GC0127/GC0128 WORKGROUP ALTERNATIVE 2

Please note all red text indicates new additions/amendments as part of the legal text to facilitate WAGCM2. This WAGCM includes the amendments below plus the Original Proposal legal text.

Figure 4a – Required capability of an **Electricity Storage Module** when operating in a mode analogous to **Demand** subject to a **Frequency** deviation of below 49.5Hz.

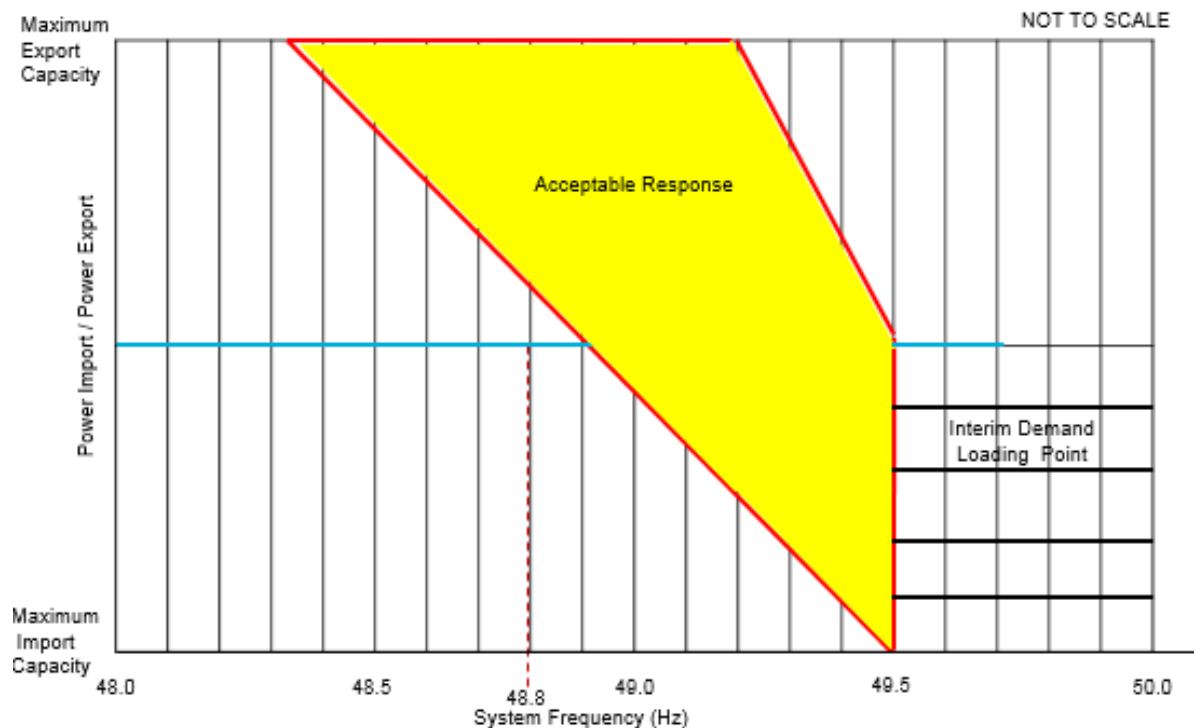
- (ii) In the event that the **System Frequency** falls below 49.5Hz, each **Electricity Storage Module**, which is operating in a mode analogous to **Demand**, and which is also capable of reversing operation from an **Interim Demand Loading Point** (including its **Maximum Capacity** (Pmax Import)) to an exporting mode of operation shall be capable of reversing its mode of operation within 20 seconds. The transition from import mode of operation to export mode of operation shall commence linearly and proportionally as soon as practicable and at the very least within at least 500ms from when the **System Frequency** falls below 49.5Hz. During this transition period, the **Electricity Storage Module** is required to remain stable over the entire operating range of the **Electricity Storage Module**.

- (iii) Each **Electricity Storage Module** which is capable of meeting the requirements of CC.6.3.7(g), shall also be capable of achieving a frequency response characteristic within the shaded area shown in Figure 4a

- (iv) In the event of an **Electricity Storage Module** remaining in a demand mode at or below a **System Frequency** of 48.9Hz or below, each **Electricity Storage Module** shall be expected to trip through the operation of automatic low frequency relays in accordance with the requirements of OC6.6.6.

- (v) All **Electricity Storage Modules** which are not capable of reversing their power flow in less than 20 seconds as described in ECC.6.3.7(g)(ii); shall be required to trip when operating in a **Demand** mode and the **System Frequency** is at or below 49.2Hz in accordance with the requirements of OC6.6.6.

Figure ECC.6.3.7.2.2.2 – Required capability of an **Electricity Storage Module** when operating in a mode analogous to **Demand** subject to a **Frequency** deviation of below 49.5Hz.

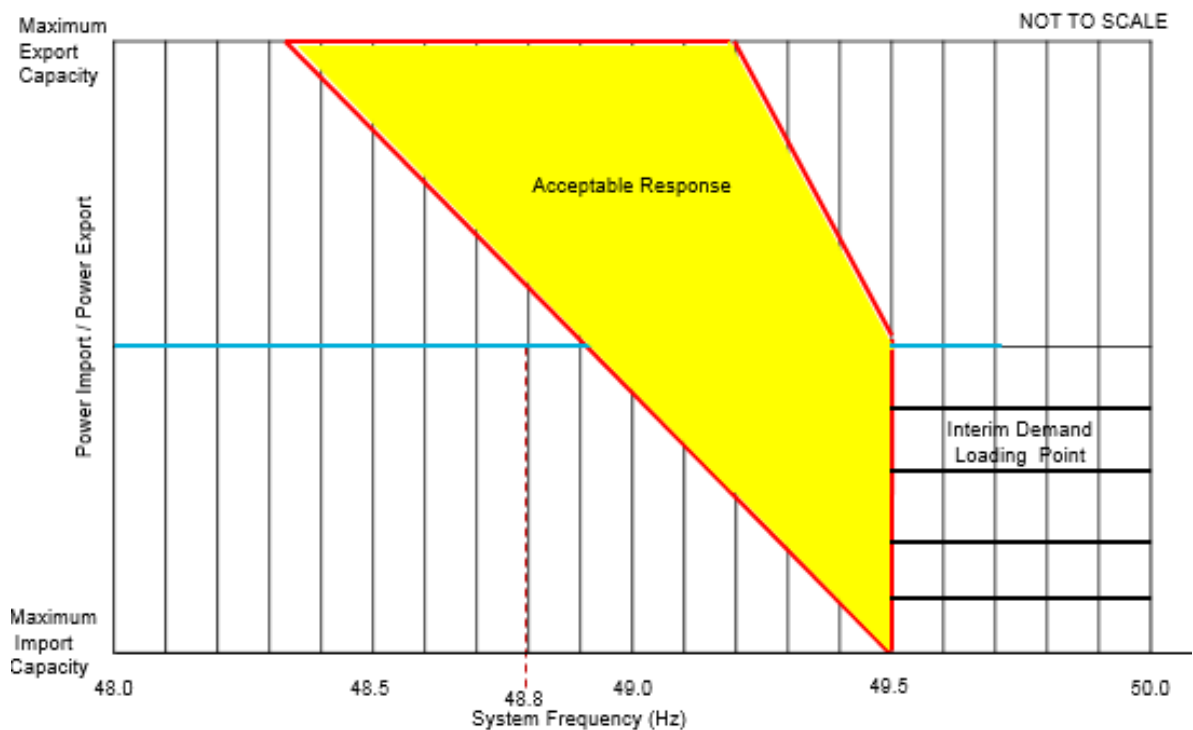
ECC.6.3.7.2.2.2 In the event that the **System Frequency** falls below 49.5Hz, each **Electricity Storage Module**, which is operating in a mode analogous to **Demand** and which is also capable of reversing operation from an **Interim Demand Loading Point** (including its **Maximum Capacity** (Pmax Import)) to an exporting mode of operation shall be capable of reversing its mode of operation within 20 seconds. The transition from import mode of operation to export mode of operation shall commence linearly and proportionally as soon as practicable and at the very least within at least within 500ms from when the **System Frequency** falls below 49.5Hz. During this transition period, the **Electricity Storage Module** is required to remain stable over the entire operating range of the **Electricity Storage Module**.

- ECC.6.3.7.2.2.3 Each **Electricity Storage Module** which is capable of meeting the requirements of ECC.6.3.7.2.2, shall also be capable of achieving a frequency response characteristic within the shaded area shown in Figure ECC.6.3.7.2.2.2.
- ECC.6.3.7.2.2.4 In the event of an **Electricity Storage Module** remains in a **Demand** mode at or below a **System Frequency** of 48.9Hz or below, each **Electricity Storage Module** shall be expected to trip through the operation of automatic low frequency relays in accordance with the requirements of OC6.6.6.

- ECC.6.3.7.2.2.7 All **Electricity Storage Modules** which are not capable of reversing their power flow in less than 20 seconds as described in ECC.6.3.7.2.2.1 shall be required to trip when operating in a **Demand** mode and the **System Frequency** is at or below 49.2Hz in accordance with the requirements of OC6.6.6.
- ECC.6.3.7.2.2.8 For the avoidance of doubt, the provision of **LFSM - UI** for **Electricity Storage Modules** is not an **Ancillary Service** and would only be required under abnormal **System Frequency** conditions and when the **Electricity Storage Module** is in an operating in a mode analogous to **Demand**.
